ITS3 activities in Bari

BBM6 Thermal Test Assembly

1) BEAM PIPE POSITION

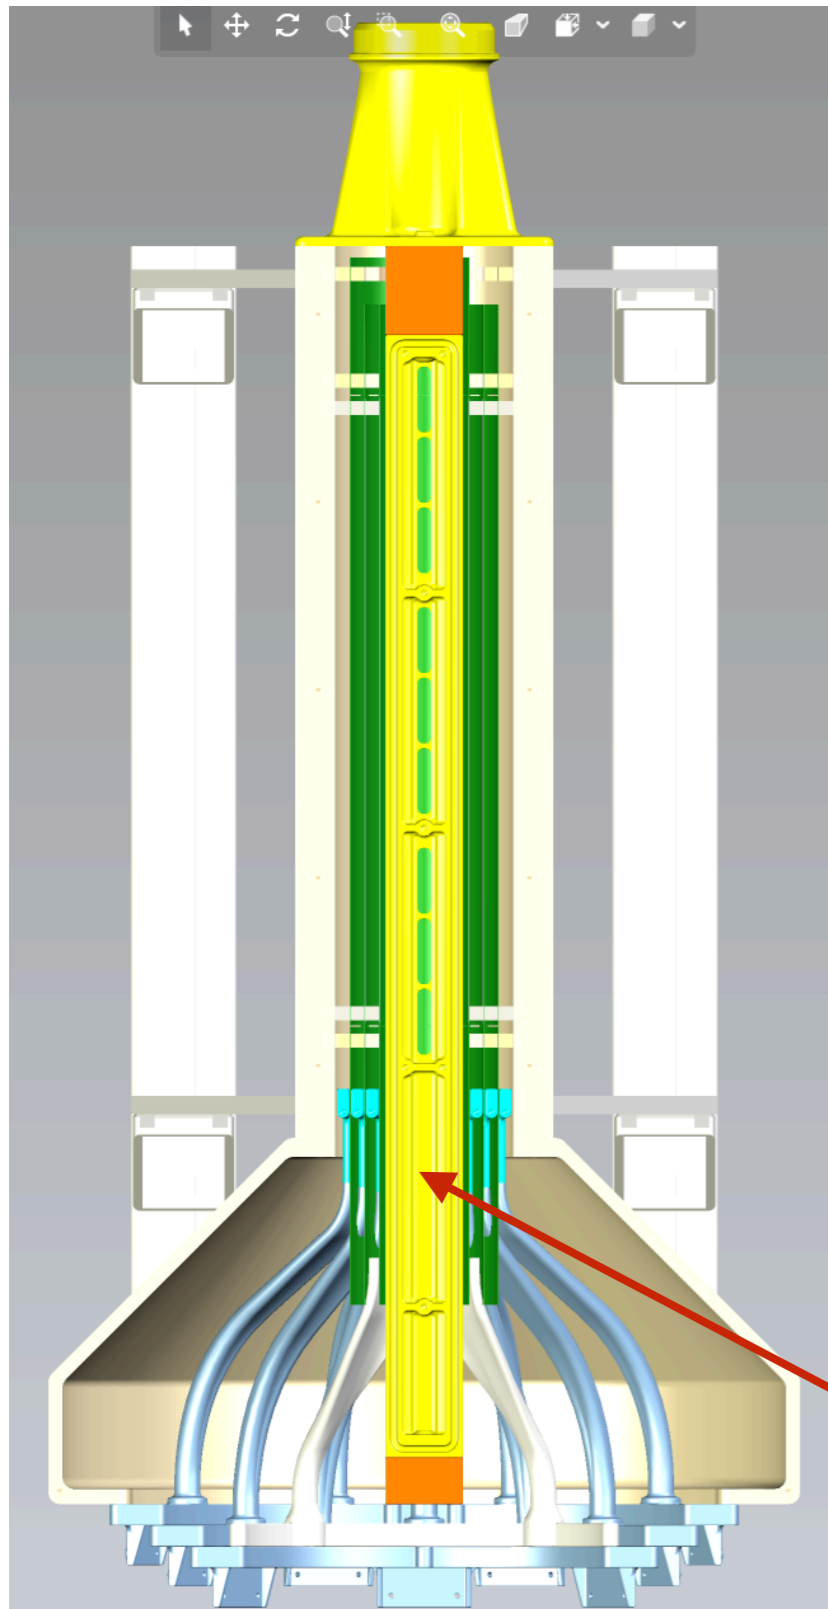
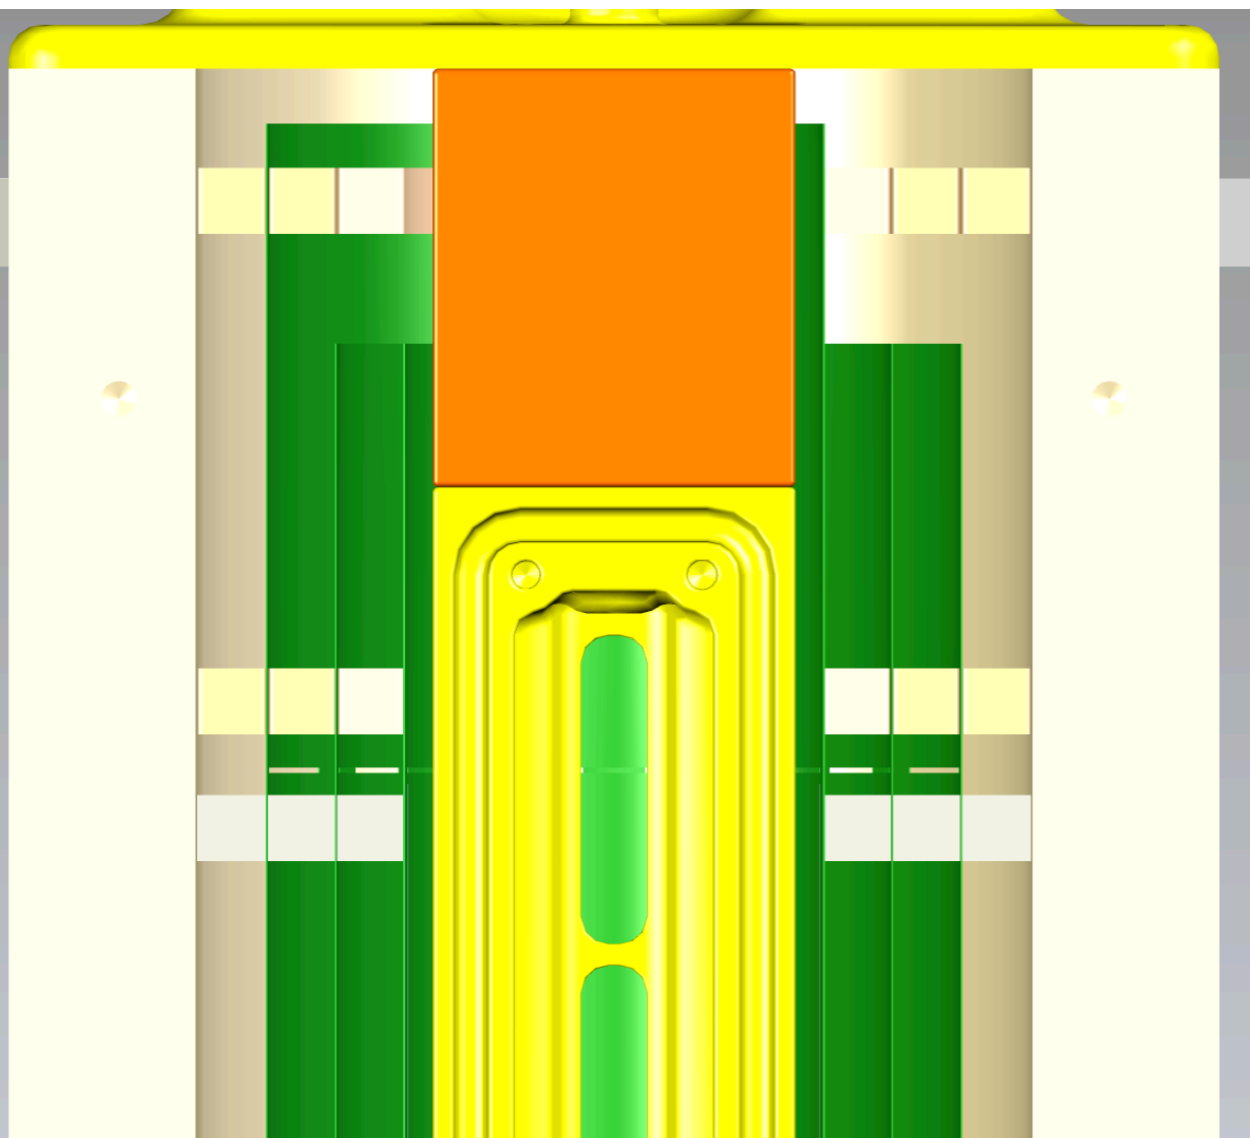
Is the positioning of the beam pipe (and particularly of the windows) fine with you?
Present position is entering windows in the sensor area.

Alternative solution, if you need to have windows also in the FPC are, is to shift everything on the C-side and open windows in the last beam-pipe section.

Fixing of the extensions to the beam-pipe not yet defined in the CAD.

Potentially, open new windows here

2) AIR DUCTS

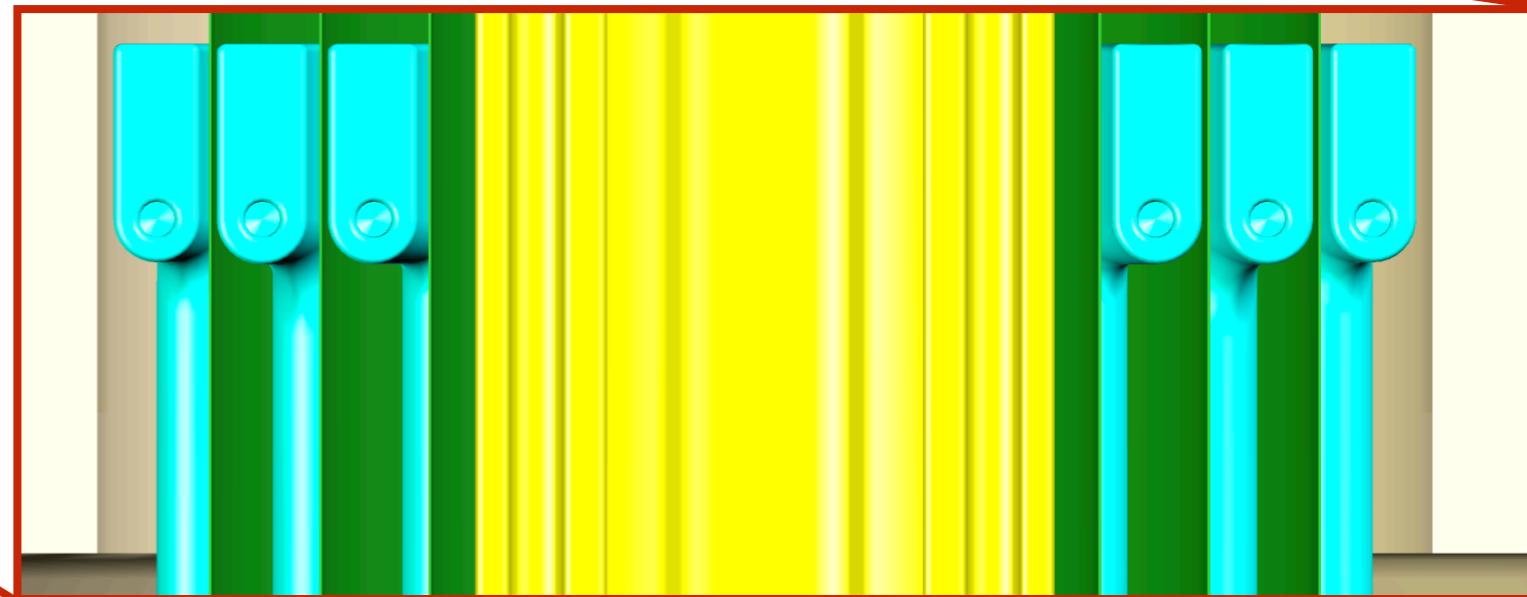
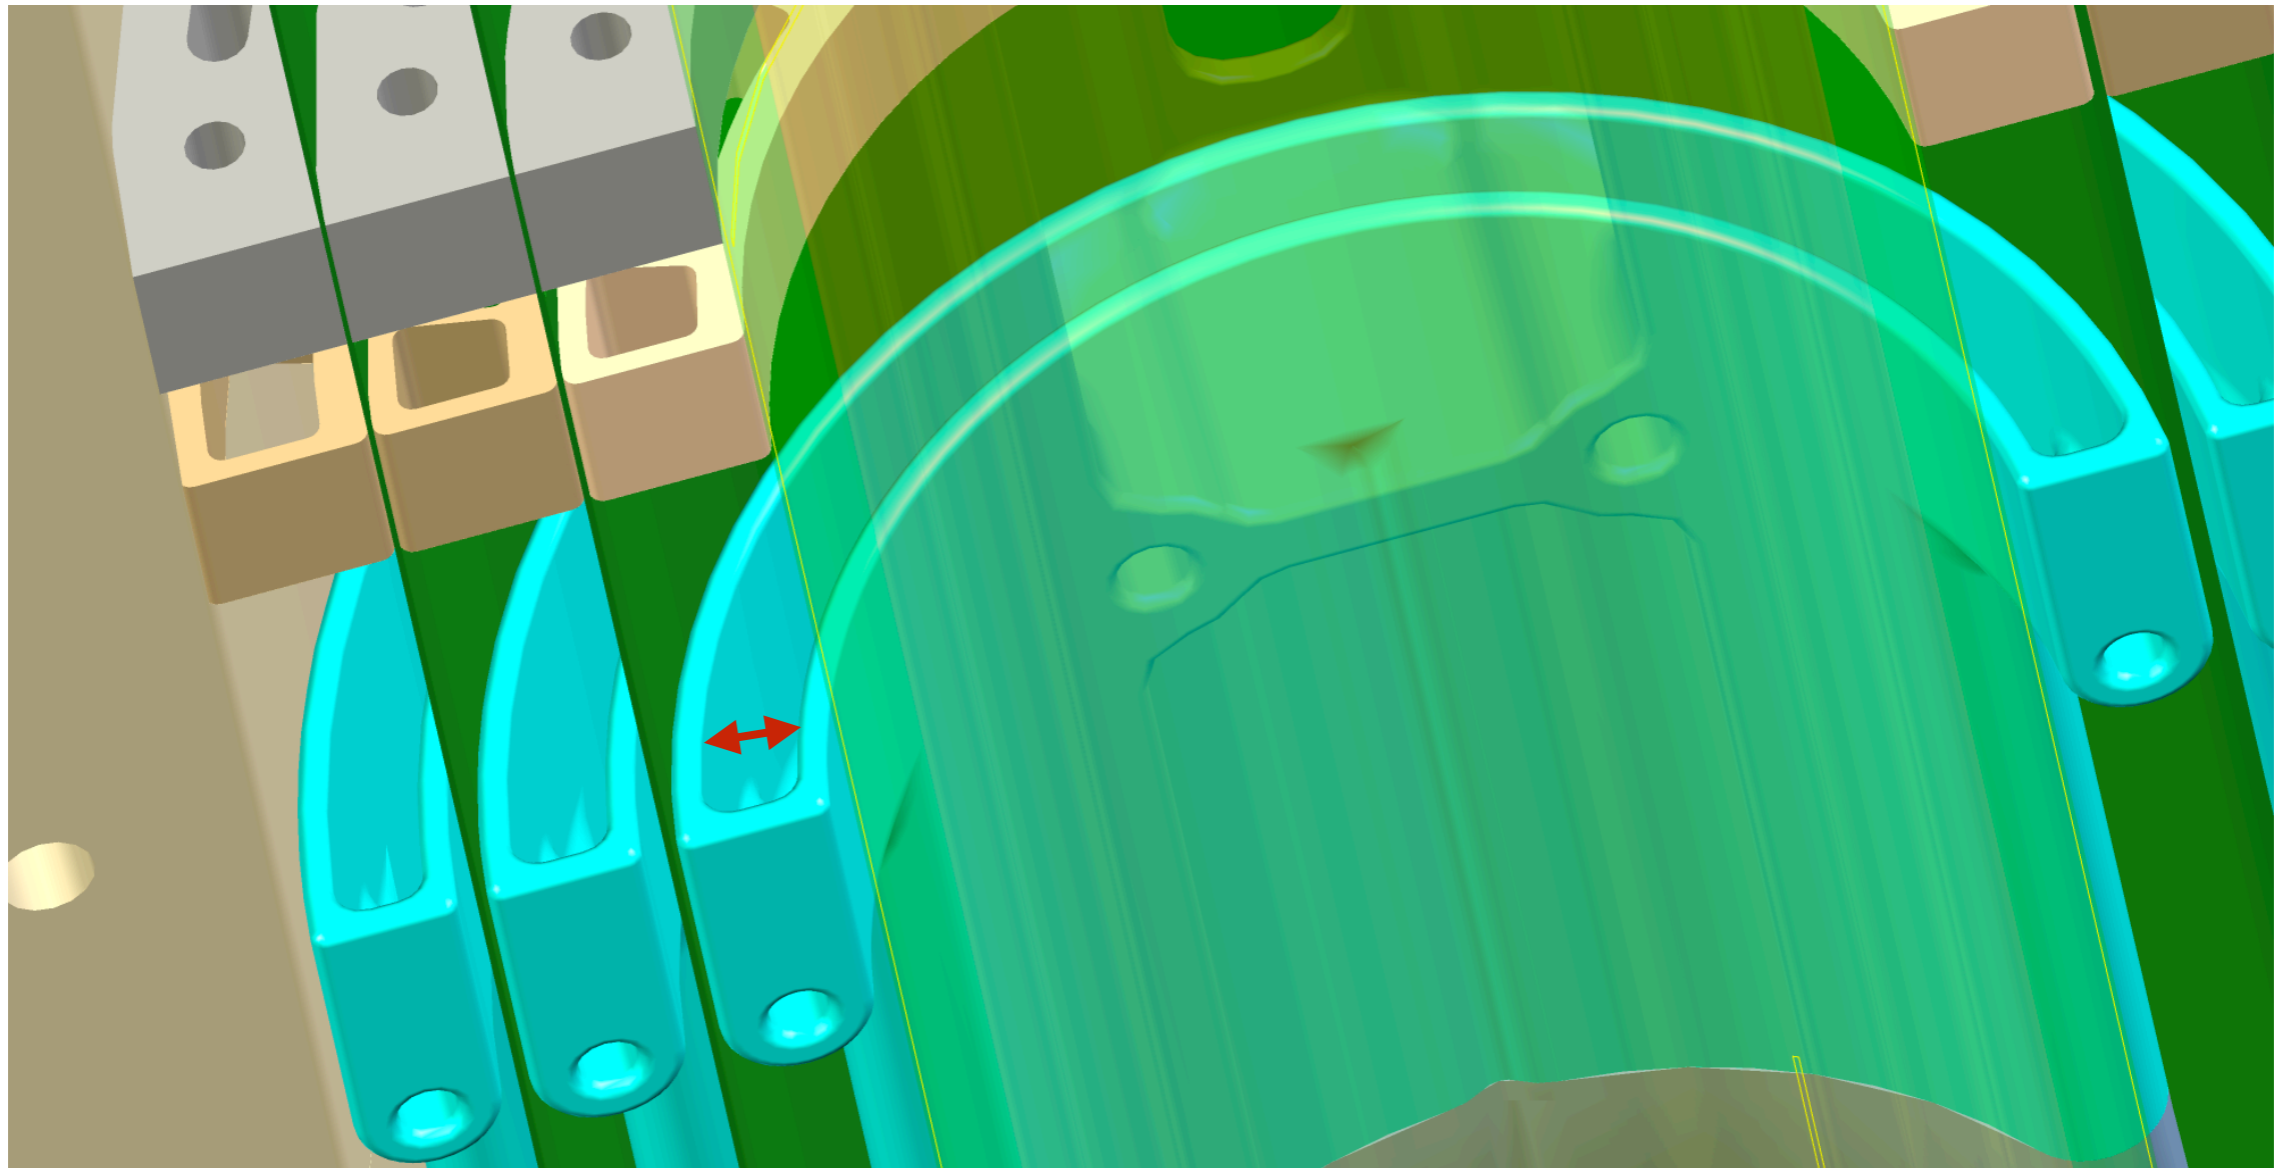
Thickness of the air ducts to be fixed.

If no update from Gael, proposed solution is to keep fixed internal dimension and make thicker wall from external side, filling the missing volume.

3) AIR DUCTS CONNECTION TO THE SHELLS

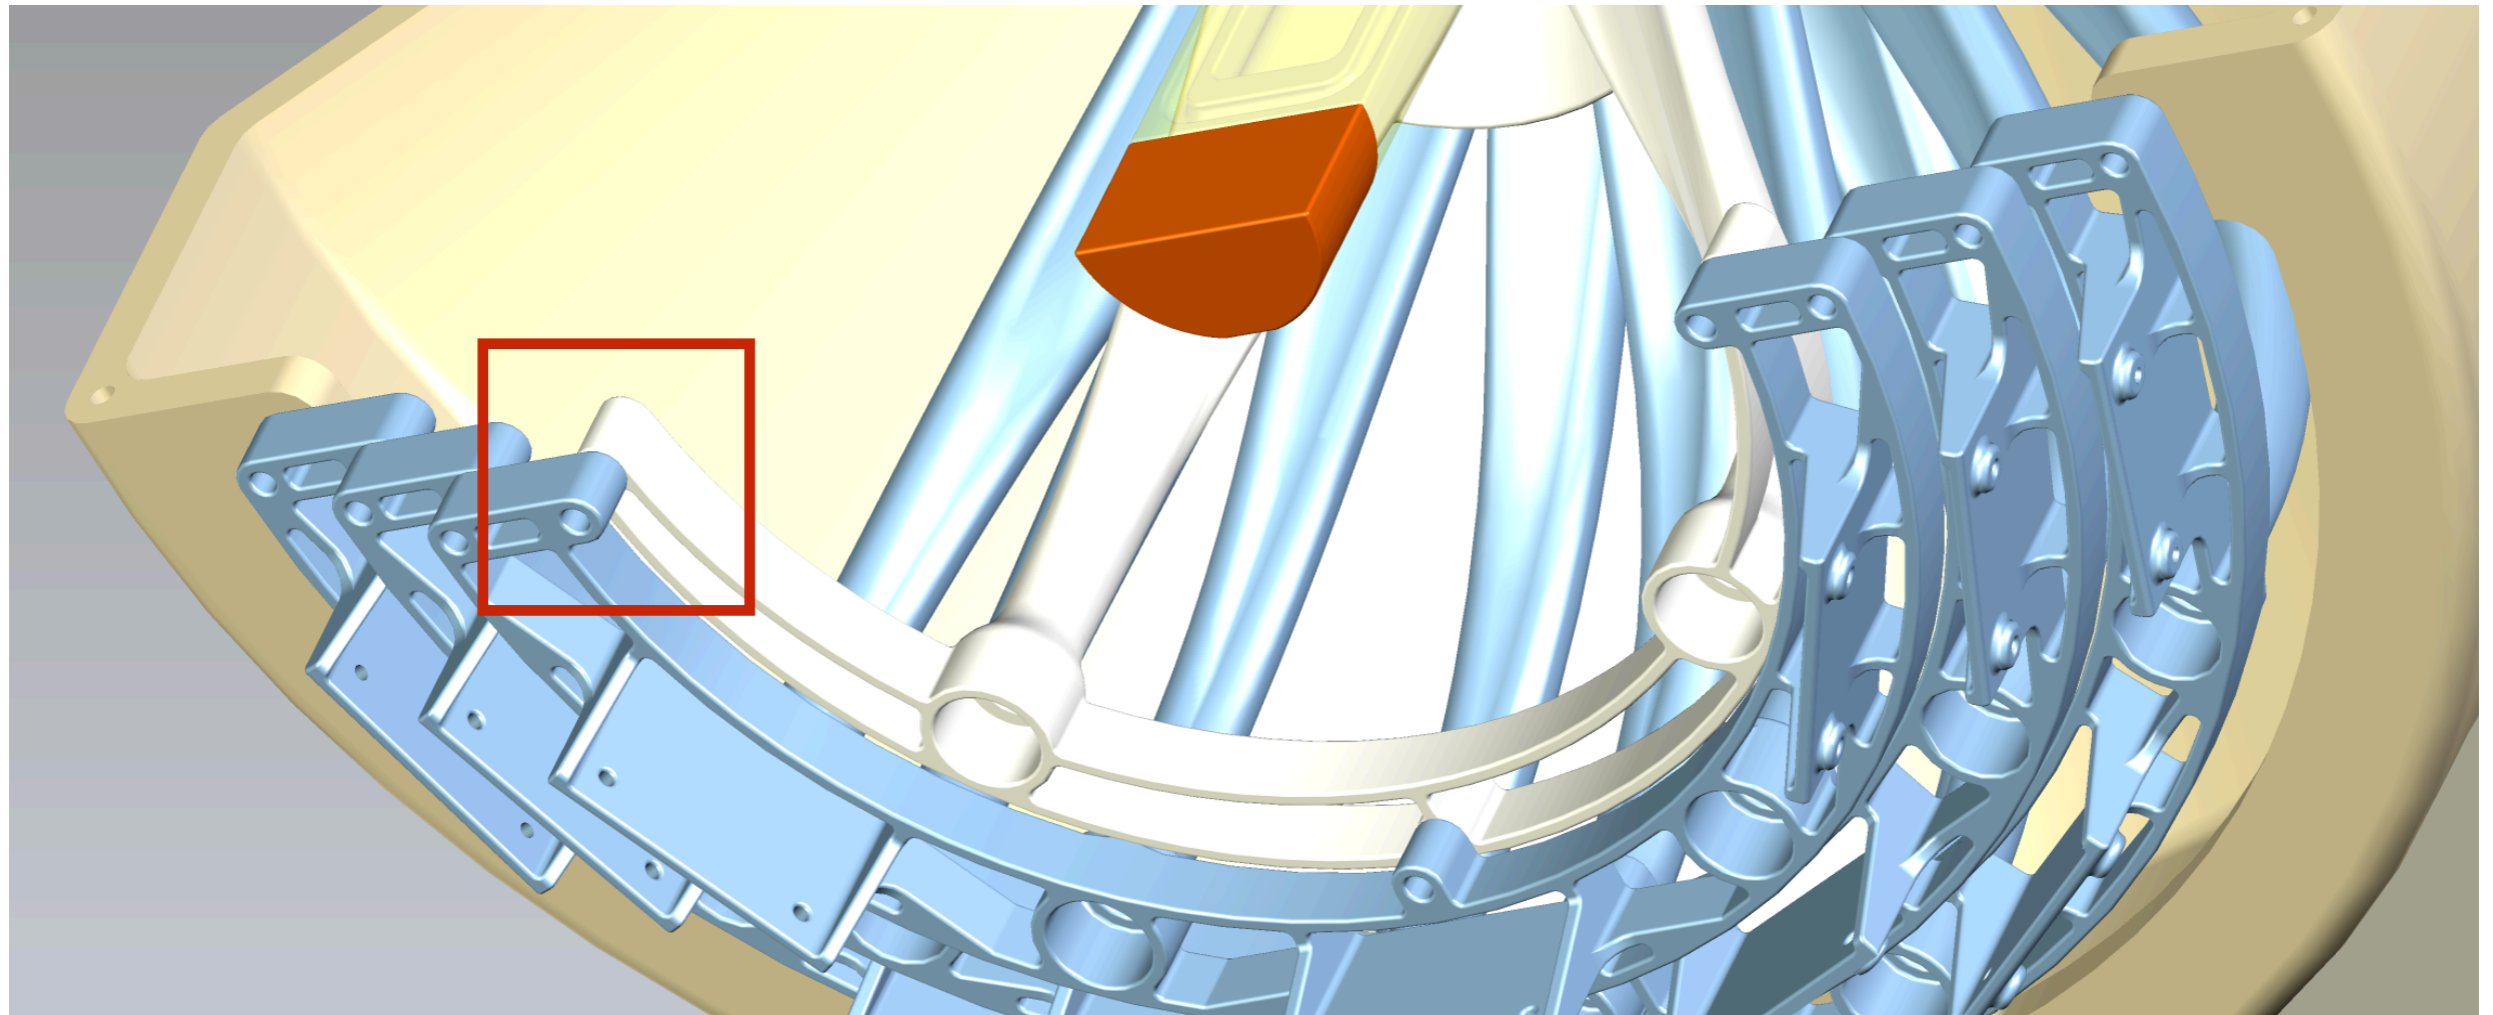
Can you give us details about the connection between the end of air ducts and the patch panel?

Do we actually need to have the patch panel?
